Date: September 10, 2025

Project Description: Juniper Sauna Co

**Project/File:** **Juniper Sauna Co / GC25-0009 / DSRFY2025-0010**

This design review application is for a 2,650-square-foot commercial building located on 0.344 acres.

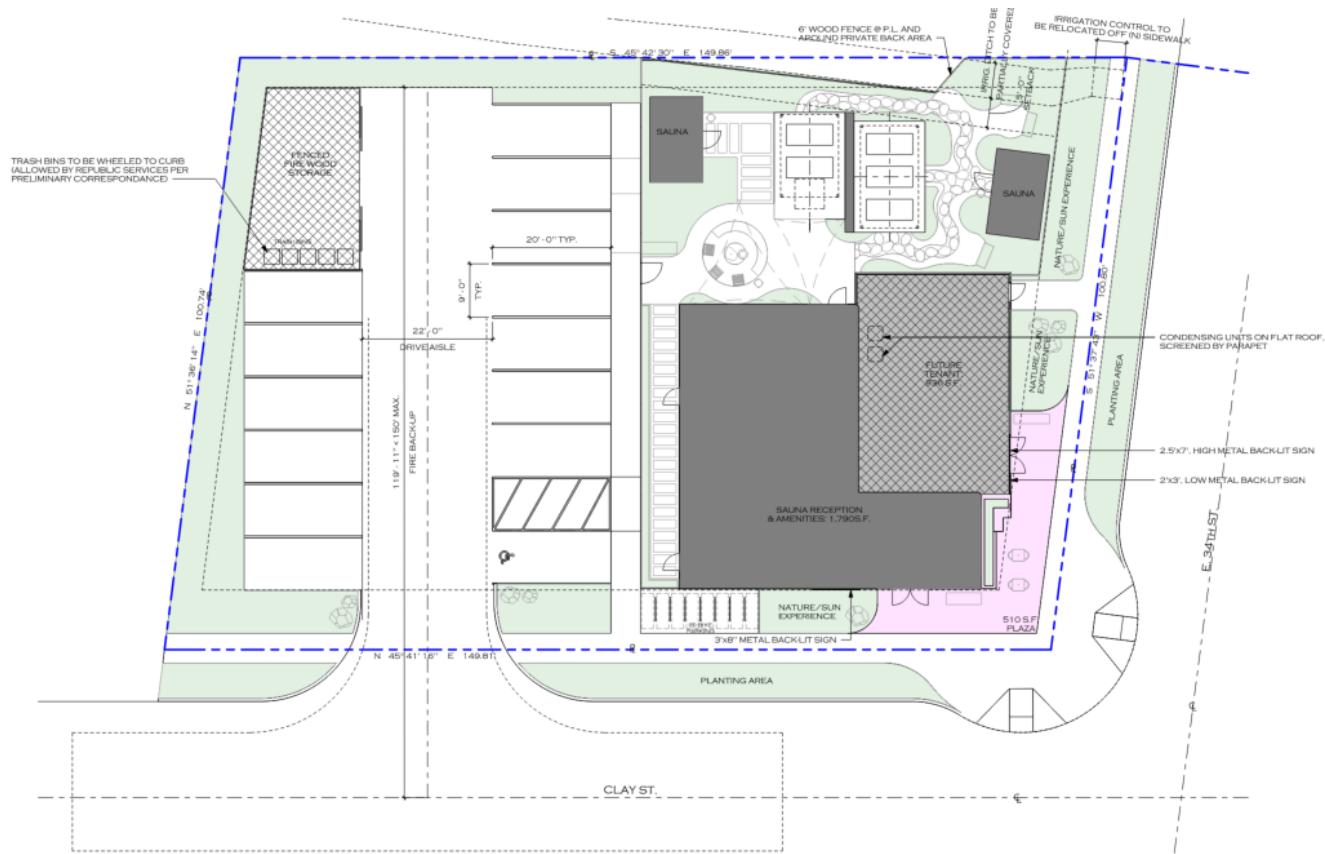
- c. Staff Comments/Recommendations:** The applicant's proposal exceeds District Policy and should not be approved, as proposed. Typically, the applicant would be required to construct Clay Street as half of a 36-foot-wide local commercial street section with curb, gutter, and 5-foot-wide concrete sidewalk. However, this segment of Clay Street is scheduled in ACHD's Five Year Plan for a pedestrian and community enhancement project. Therefore, in lieu of improving Clay Street with pavement widening, vertical curb, gutter, and sidewalk, the applicant should provide ACHD with a road trust deposit in the amount of \$27,600. ACHD will then use the road trust deposit money for pavement widening, vertical curb, gutter, and 5-foot-wide concrete sidewalk abutting the site as part of the Clay Street community project.

The Five Year Plan improvements to Clay Street also include the construction of a bulb-out at the intersection of Clay Street and 34<sup>th</sup> Street. Therefore, the applicant's proposal to construct a bulb-out located at the site's southeast corner should not be approved as proposed.

- c. Staff Comments/Recommendations:** The applicant's proposal does not meet District Policy and should not be approved as proposed. To meet District Policy, the applicant should be required to construct 34<sup>th</sup> Street as half of a 36-foot-wide local commercial street section with curb, gutter, and 5-foot-wide concrete sidewalk. If detached sidewalk is desired, then a minimum 8-foot-wide landscape barrier should be provided.

The applicant should be required to dedicate right of way on 34<sup>th</sup> Street extending to 2-feet behind the back of sidewalk. For detached sidewalks, the applicant may dedicate right-of-way to extend 2-feet behind the back of curb and provide a right-of-way easement from the edge of right-of-way to 2-feet behind the back of sidewalk. Sidewalk should be located entirely within the right-of-way or entirely within the easement.

c. **Staff Comments/Recommendations:** The applicant's proposal meets District Policy and should be approved, as proposed.

1. Provide ACHD with a road trust deposit in the amount of \$27,600. ACHD will then use the road trust deposit money for pavement widening, vertical curb, gutter, and 5-foot wide concrete sidewalk abutting the site as part of the Clay Street community project.

2. Construct 34<sup>th</sup> Street as half of a 36-foot-wide local commercial street section with curb, gutter, and 5-foot-wide concrete sidewalk. If detached sidewalk is desired, then a minimum 8-foot-wide landscape barrier should be provided.

3. Dedicate right of way on 34<sup>th</sup> Street extending to 2-feet behind the back of sidewalk. For detached sidewalks, the applicant may dedicate right-of-way to extend 2-feet behind the back of curb and provide a right-of-way easement from the edge of right-of-way to 2-feet behind the back of sidewalk. Sidewalk should be located entirely within the right-of-way or entirely within the easement.

4. Construct a 20-foot-wide, paved driveway from the site onto Clay Street located 45-feet east of the site's west property line.
5. Submit civil plans to ACHD Development Services for review and approval. The impact fee assessment will not be released until the civil plans are approved by ACHD.
